102-07981-MLL/MDD  
October 18, 2019

Subject: **Palo Verde Nuclear Generating Station (PVNGS) Units 1, 2, and 3 and Independent Spent Fuel Storage Installation (ISFSI) Docket Nos. STN 50-528, 50-529, 50-530 and 72-44 Renewed Operating License Nos. NPF-41, NPF-51, NPF-74 License Amendment Request for Changes to Emergency Plan Staffing Requirements**

### **License Amendment Request Changes to Emergency Plan Staffing Requirements**

FIGURE 1 ONSHIFT EMERGENCY ORGANIZATION

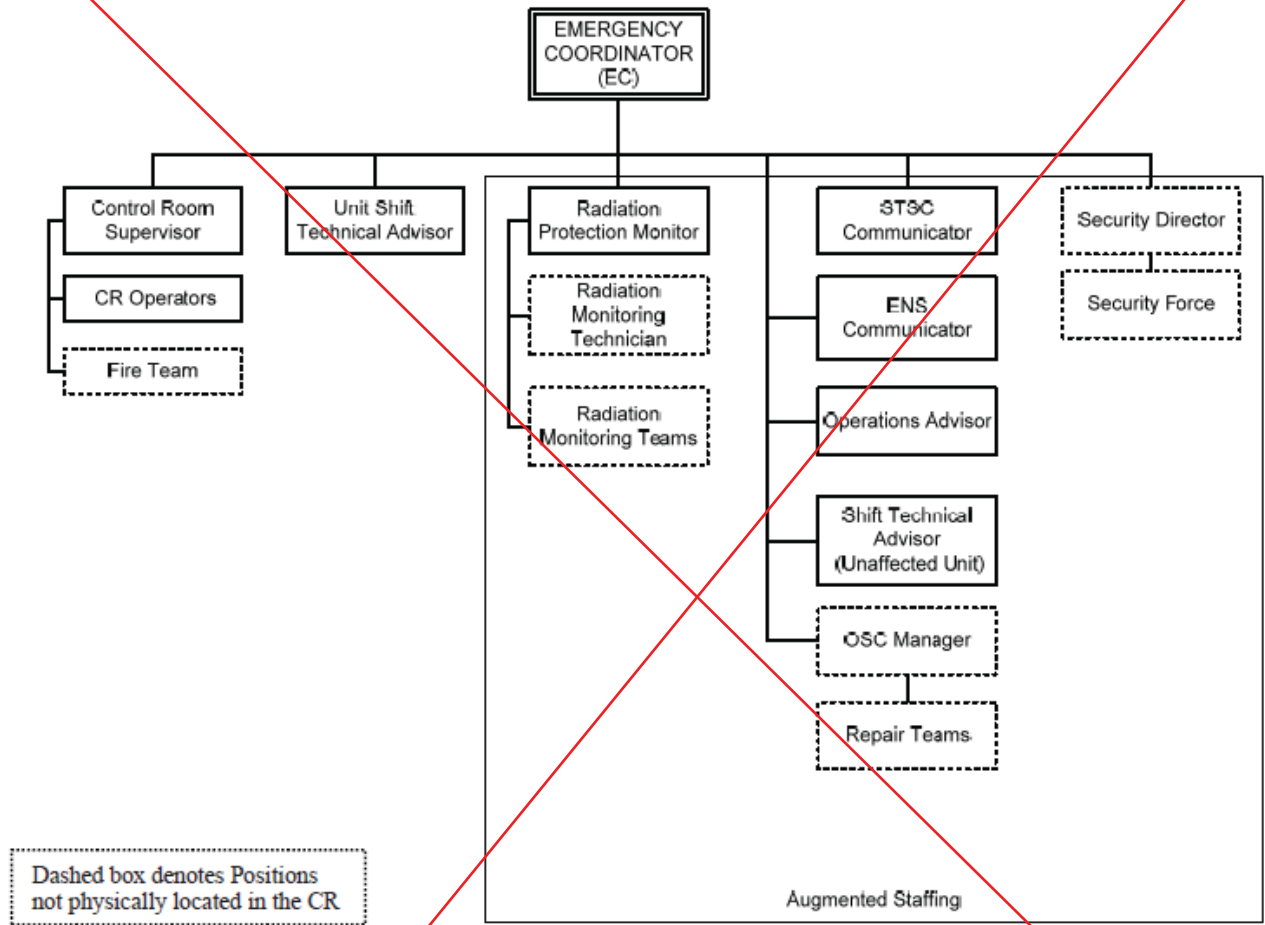
~~The On-shift Emergency Organization (Figure 1) consists of the following positions:~~

The On-shift Emergency Organization (Figure 1) consists of the following positions:

FIGURE 2 TECHNICAL SUPPORT CENTER ORGANIZATION

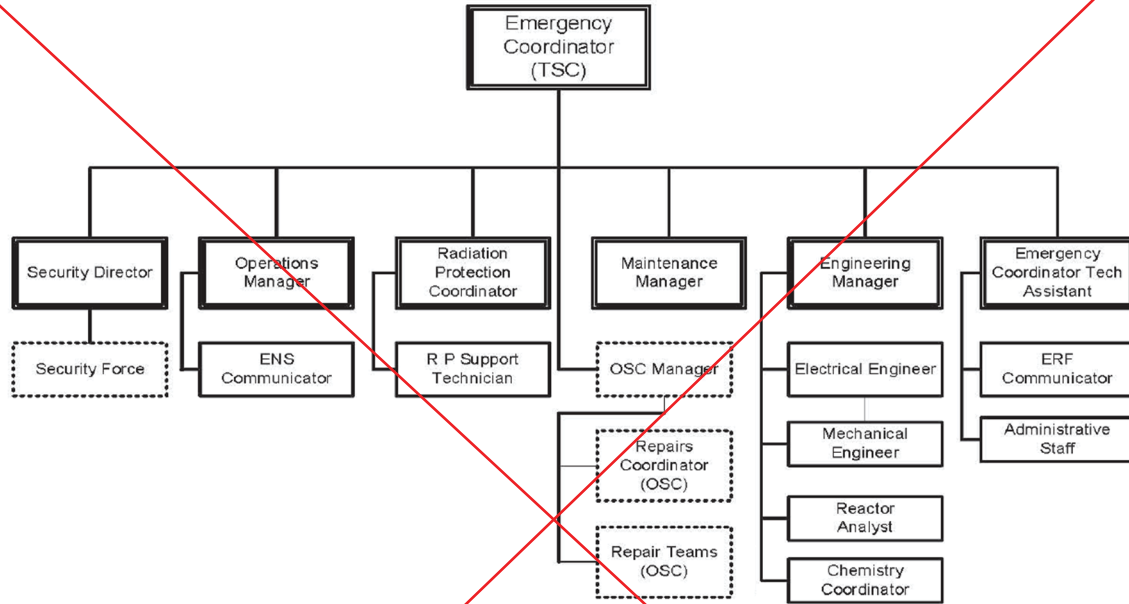
~~The TSC Organization (Figure 2) is located on-site and consists of the following positions.~~

The Augmented Emergency Response Organization that staffs the Technical Support Center (Figure 2) consists of the following positions:

**FIGURE 3 OPERATIONS SUPPORT CENTER ORGANIZATION**

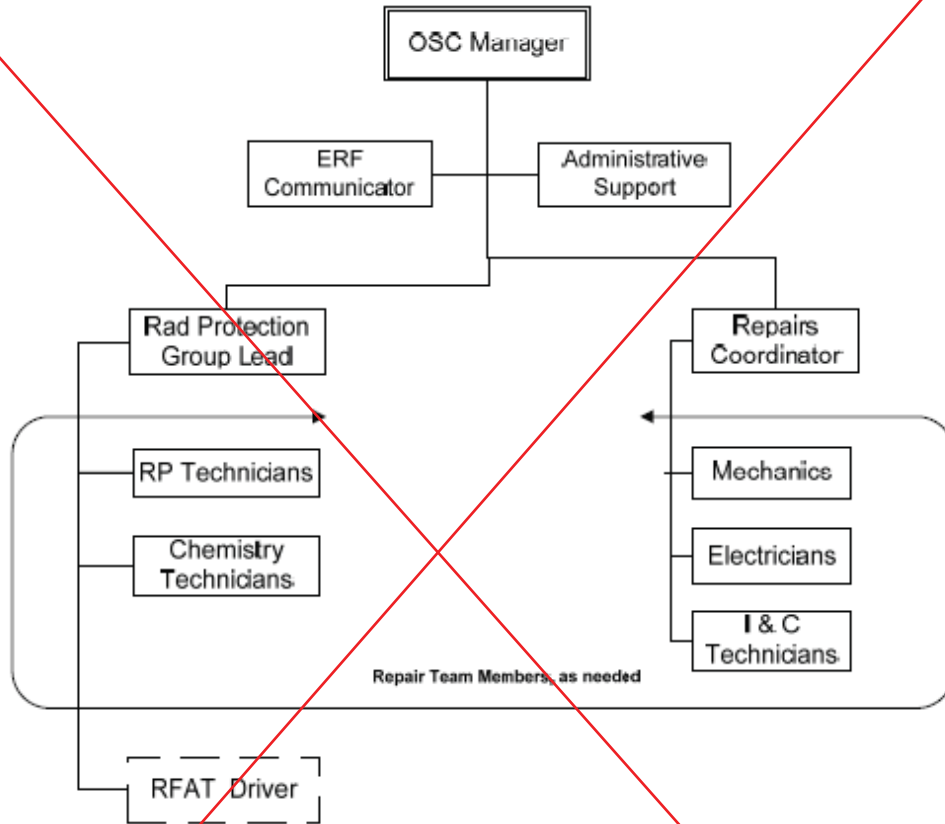
~~The OSC Organization (Figure 3) is located onsite and consists of the following positions.~~

**FIGURE 4 EMERGENCY OPERATIONS FACILITY ORGANIZATION**

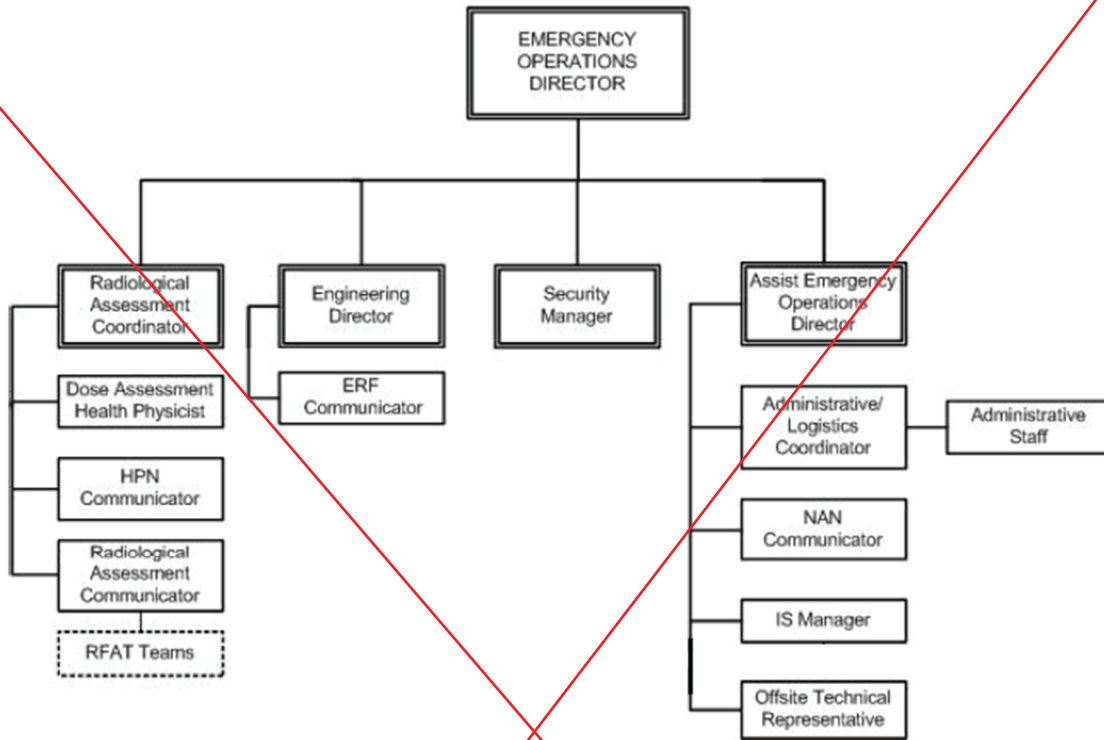
~~The EOF Emergency Organization is illustrated in Figure 4. The interfaces between the Onsite and Offsite Emergency Organizations are shown in Figure 6.~~

**FIGURE 5 JOINT INFORMATION CENTER ORGANIZATION**

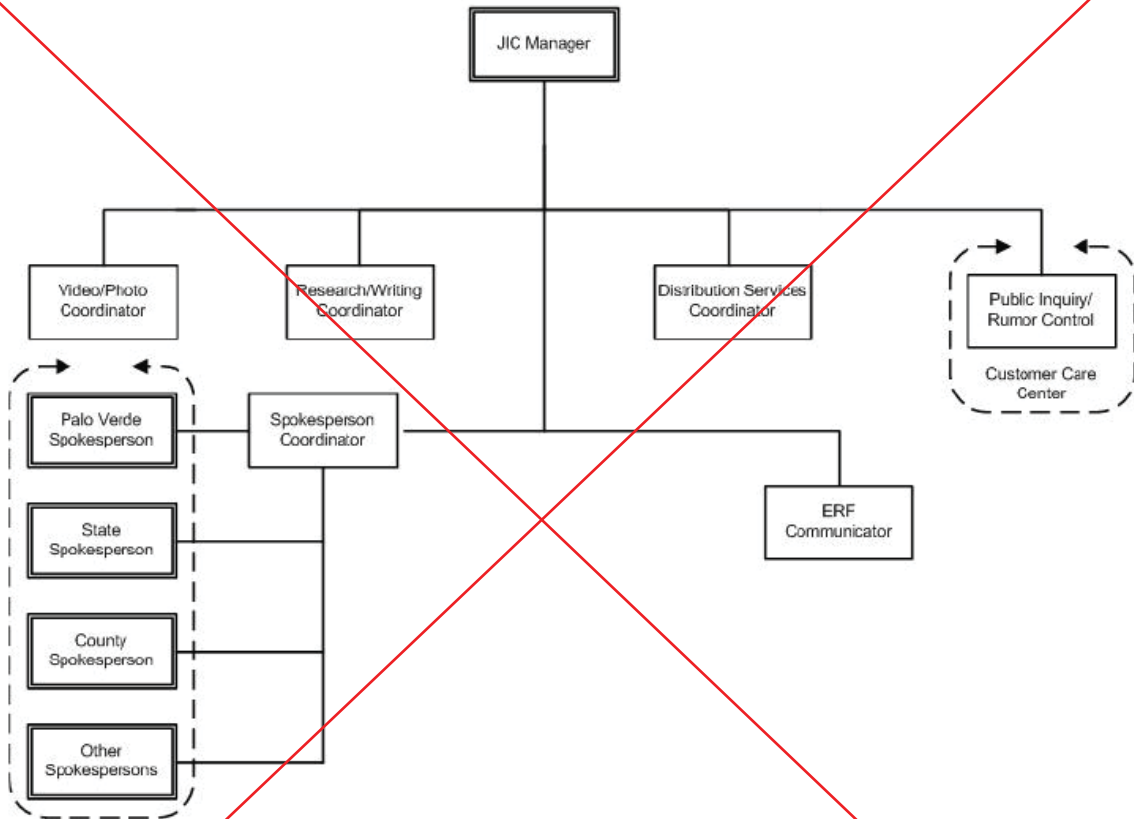
~~The JIC Organization (Figure 5) is located offsite and consists of the following positions.~~
